# Access Compliance Report

## Public Rights-of-Way

Intersection ID: 12544	Main Street: E_8TH_ST	Cross Street: N_ALEXANDER_ST	Location: W
ADA ID: 51A05841C443	Ramp Type: PerpDiag	Initial Pass/Fail: Fail	Overall Compliance: No
			Severity Score: 33.75

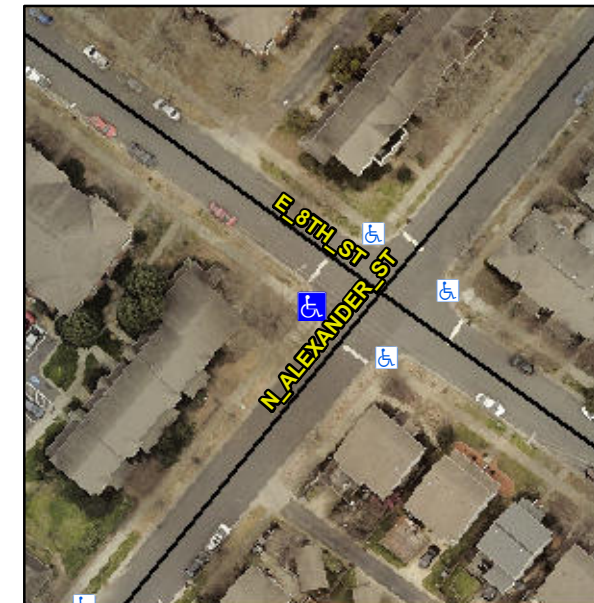
**Not Found, R304.5.1, R304.2.2, R304.5.3**

Compliance	Description	Data	Compliance	Description	Data
N/A	Ramp Length (in)	29.0	No	Ramp Slope (%)	10.3
No	Ramp Width (in)	36.0	No	Ramp XSlope (%)	5.3
N/A	Flare Type LT	N/A	N/A	Flare Type RT	N/A
N/A	Flare Slope LT (%)	N/A	N/A	Flare Slope RT (%)	N/A
N/A	Flare Traversable LT?	N/A	N/A	Flare Traversable RT?	N/A
N/A	Landing Length (in)	N/A	N/A	DWS Provided?	N/A
N/A	Landing Width (in)	N/A	N/A	DWS Contrast?	N/A
N/A	Landing Slope (%)	N/A	N/A	DWS Length (in)	N/A
N/A	Landing X Slope (%)	N/A	N/A	DWS Full Width?	N/A
N/A	Landing Curb? (Y/N)	N/A	N/A	DWS Offset (in)	N/A
N/A	Shared Landing?	N/A			
N/A	Gutter Ponding?	N/A	N/A	Gutter Slope (%)	N/A
N/A	Gutter Lip Ht (in)	N/A	N/A	Gutter X Slope (%)	N/A
N/A	Painted X Walk1?	No	N/A	Painted X Walk2?	No
	X Walk 1 Direction	To SE		X Walk 2 Direction	To NE
N/A	X Walk 1 Width (in)	N/A	N/A	X Walk 2 Width (in)	N/A
	X Walk 1 Slope (%)	9.2		X Walk 2 Slope (%)	11.5
	X Walk 1 X Slope (%)	12.1		X Walk 2 X Slope (%)	7.0

**Remove & Replace Curb Ramp With Two New Directional Ramps or Equivalent.**
